REFERENCE:	Nova Bus Manuals
SECTION:	03-402 Windshield wipers
RS N°:	MQR 7621-583
EFFECTIVE IN PROD.:	L692-71 (2013JA)

SUBJECT:	Wipers' central mechanism
JUSTIFICATION:	Possible interference between the underside of the dash and the wiper's pivot.

Figure 8 - Location of the Bracket

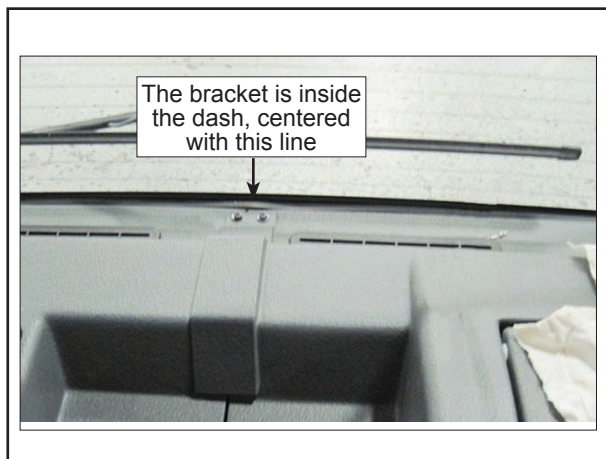
- 1.10. Under the dash, in the middle section (Figure 8), remove the two screws from the bracket that retains the dash to the structure (Figure 9).

Figure 10 - Spacer Under the Bracket

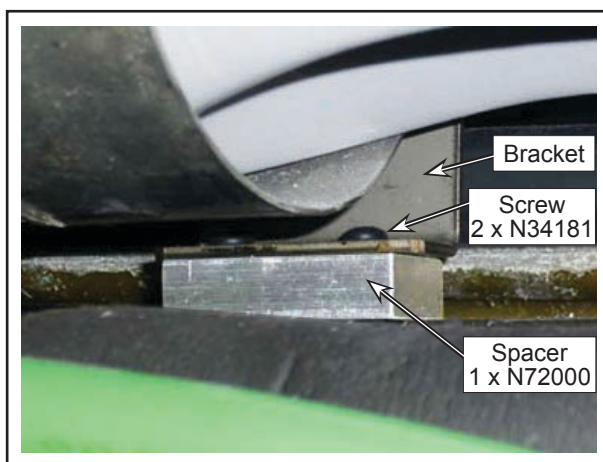
- 1.11. Between the bracket and the structure, add the spacer. Use the new screws to keep it in place. See Figure 10.

Figure 11 - C-clip in Front of the Pivot

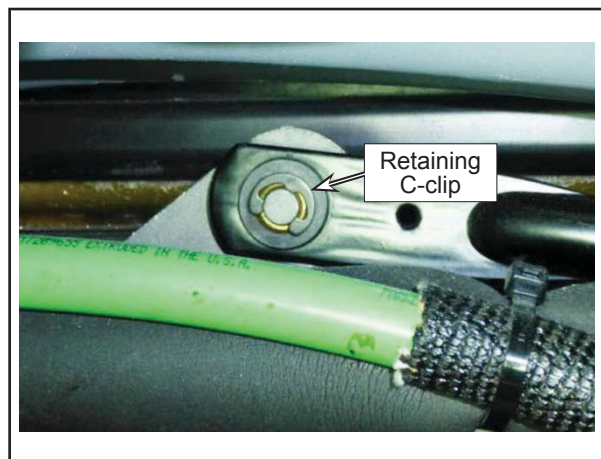
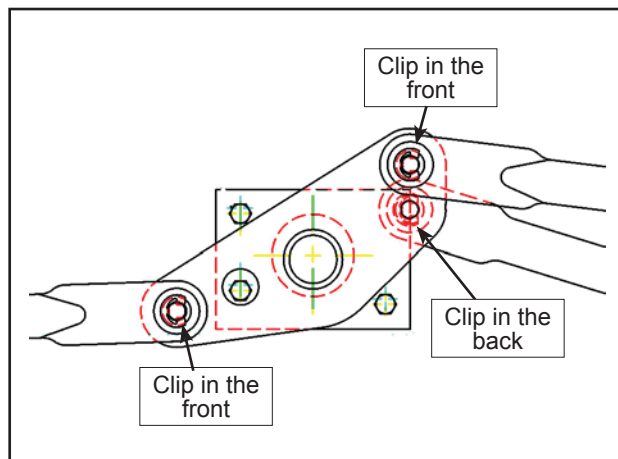
- 1.12. Using the retained hardware, re-install the right side dash panel.
- 1.13. From outside the bus, verify that the three C-clips (N8883532) are in place on the central pivot (Figures 11 and 12). If not, install a clip where one is missing. ❖
